TITLE: 2019 ~ 2022 W800 & W800 CAFE HORN REPLACEMENT

RECALL

IMPORTANT SAFETY RECALL NHTSA RECALL NO. 22V-122

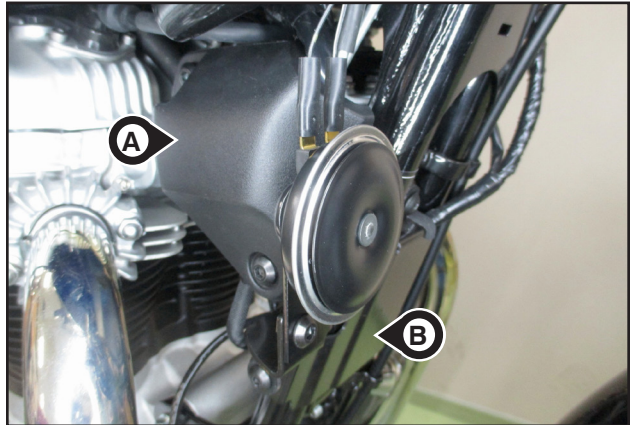
- Remove the seat.
- Remove the ECU.
- Disconnect negative battery terminal.
- Remove and retain cover [A].
- Remove and retain cover [B].

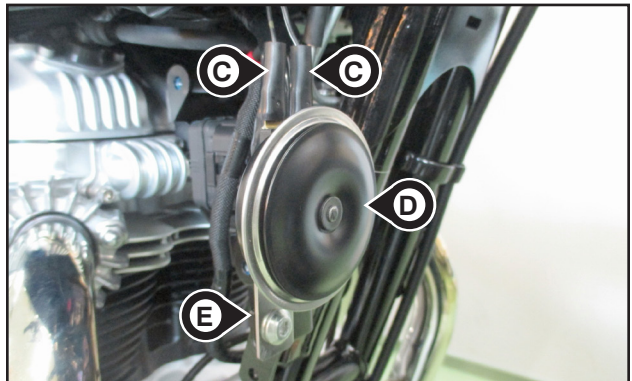
- Disconnect both horn connectors [C].
- Remove Horn [D].
- Remove Bracket [E].

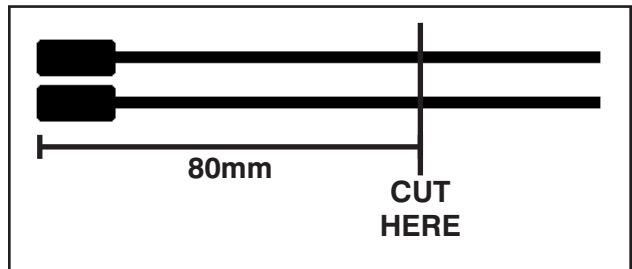
- Cut each lead wire 80mm from the end of the lead connector.

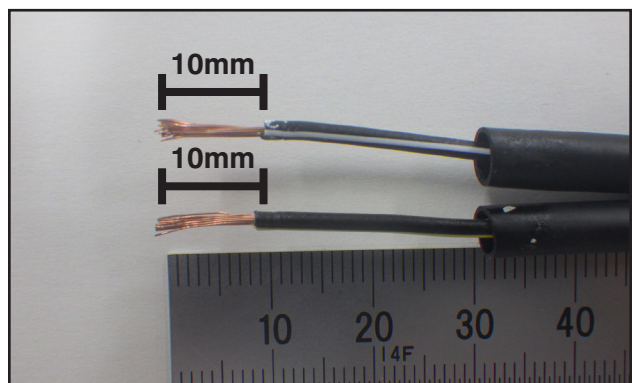
- Strip 10mm of insulation from the ends of both wires making sure that both wires are the same length when done.

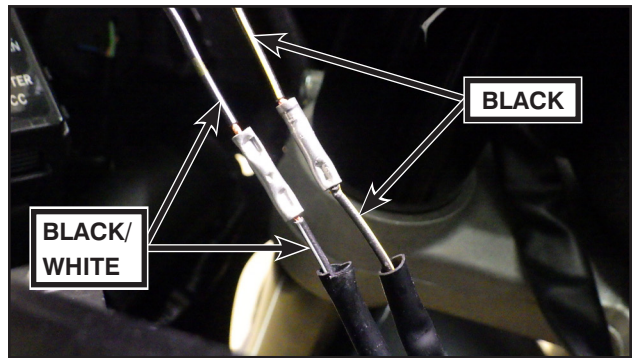
- Match black and black/white wires of the main and repair harness
- Fully insert the stripped ends of the main harness into the butt connectors of the repair harness.

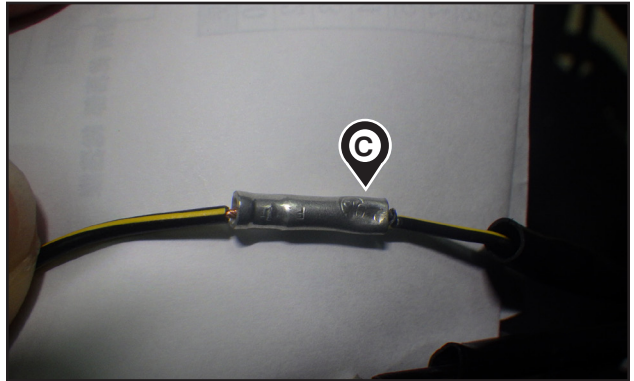
- Crimp [C] both butt connectors firmly.

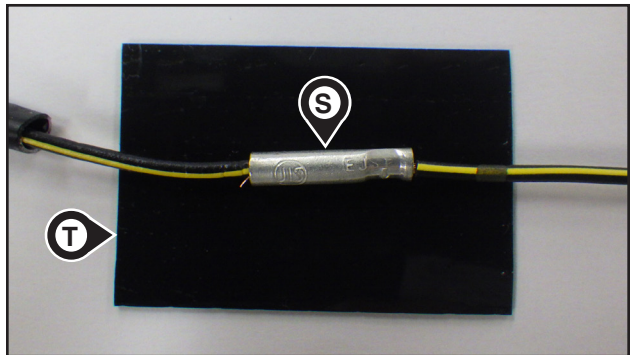
- Position one butt splice [S] on the center of one piece of tape [T] from the repair kit and fold the tape over onto itself.
- Repeat for the other connector.

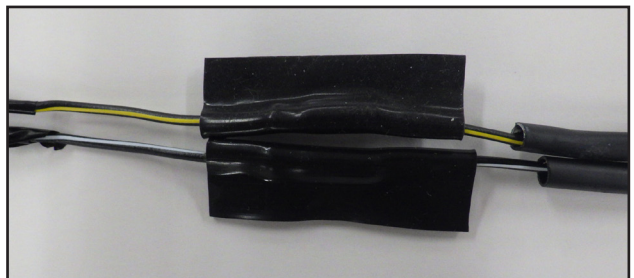
- Both of the taped connectors will look like this.

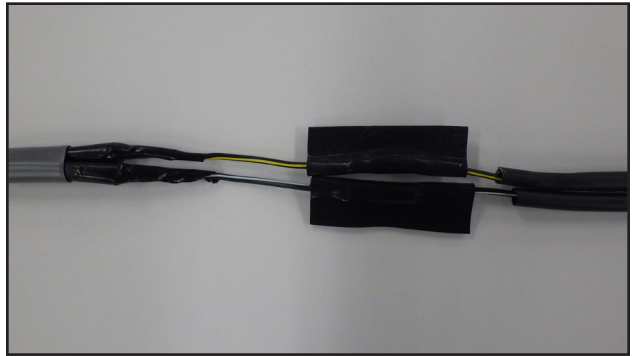
- Wrap the entire repair with 2 layers of plastic tape from the repair kit.

- The finished repair will look like this.

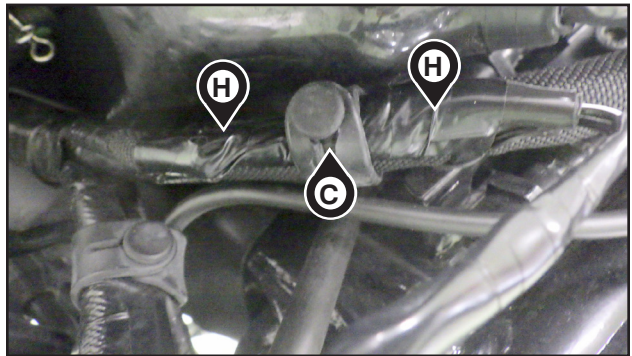
- Route the harness [H] as shown so the clamp [C] is in the center of the repair.

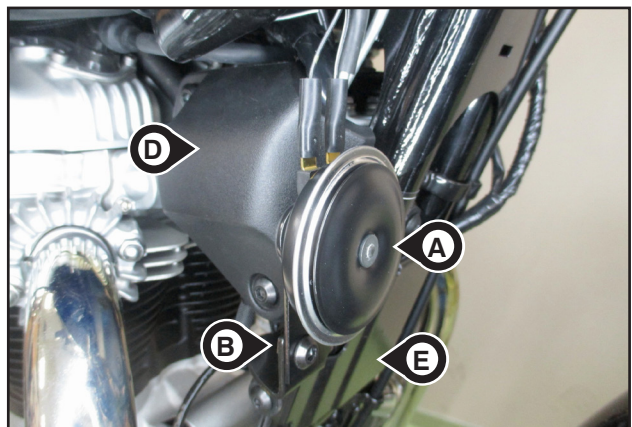
- Install new horn [A] and bracket [B].
- Install covers [D] and [E].
- Install left side of upper inner fairing.
- Connect negative battery terminal.
- Install the ECU.
- Test the horn.
- Install the seat.

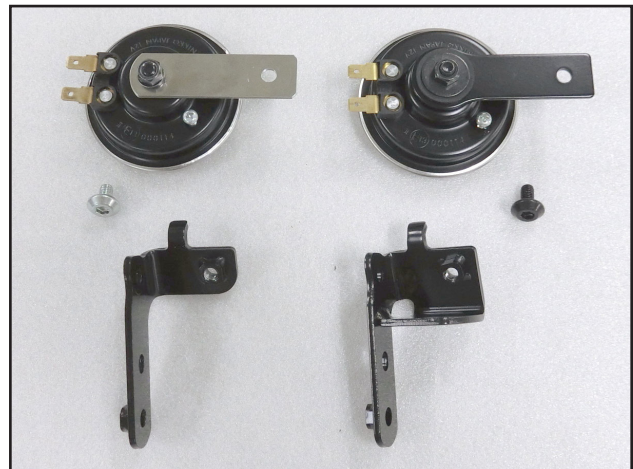
The new parts will serve as repair verification.

OLD

NEW
